# DEVELOPMENT REVIEW BOARD REPORT

CASE NUMBER/  
PROJECT NAME      **79-DR-2005**  
                             **The Upton**

REQUEST                      Request for approval of a site plan and elevations for a 10-unit condominium residential development.

the **upton**  
site plan  
1" = 20'-0"

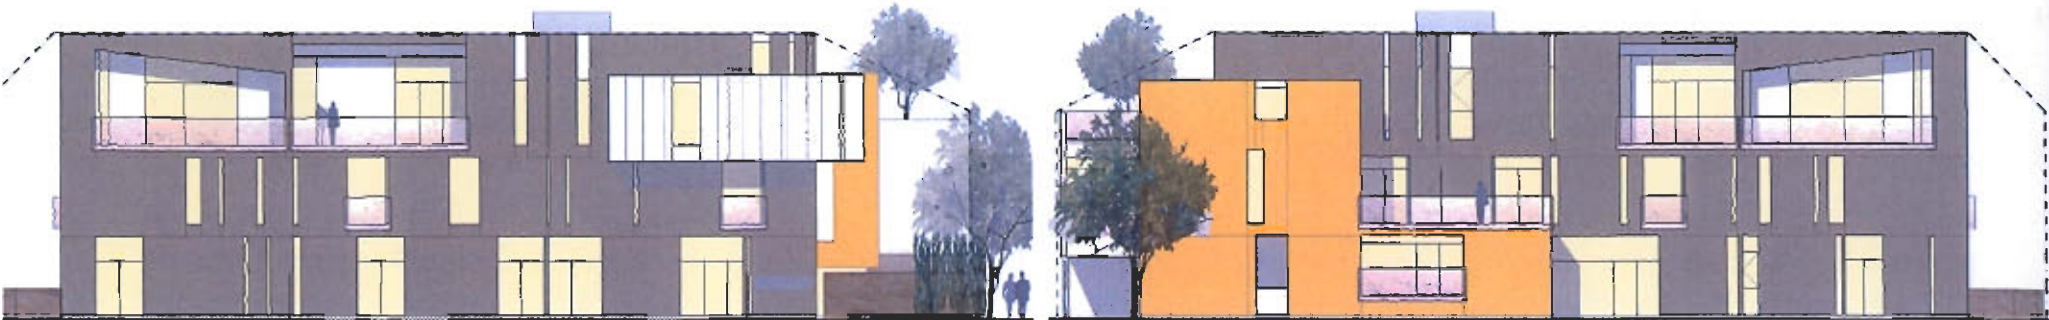
The site plan shows a U-shaped building with a courtyard in the center, and access to below ground parking from Shoeman Lane. A pedestrian access to the courtyard is also provided from Shoeman Lane. The property's pool location is proposed at the edge of the landscaping, in the front of the building. Parking will be provided in an underground garage.

the **upton**  
*Like a modern day victorian*  
**elevations**

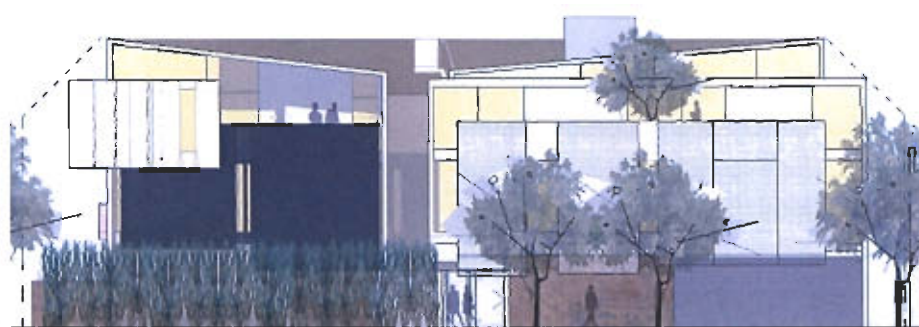
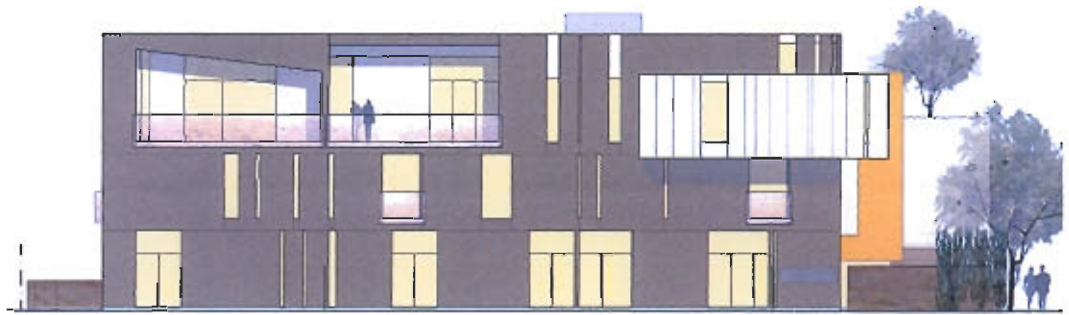
The elevations show a geometric pattern of square and rectangular forms with recesses and voids created through placement of patios, elevation changes, and window placement.

This part of the Downtown does not have design guidelines like the Main Street area has. In evaluation of the proposal staff thus looks to the character of the neighborhood within which the site is located. This site is located in the Entertainment District, which has an eclectic architectural development pattern. Therefore, staff considers this concept acceptable.

Staff has received comments from two neighboring property owners. Their concerns are that the proposed architectural style is not consistent with this neighborhood and that the colors are inappropriate.

- A. *The building height shall be reduced as necessary to comply with the height restriction of the zoning ordinance.*
- B. *The elevations shall be revised to clearly and accurately demonstrate that the inclined stepback planes established by the Zoning Ordinance are not encroached.*
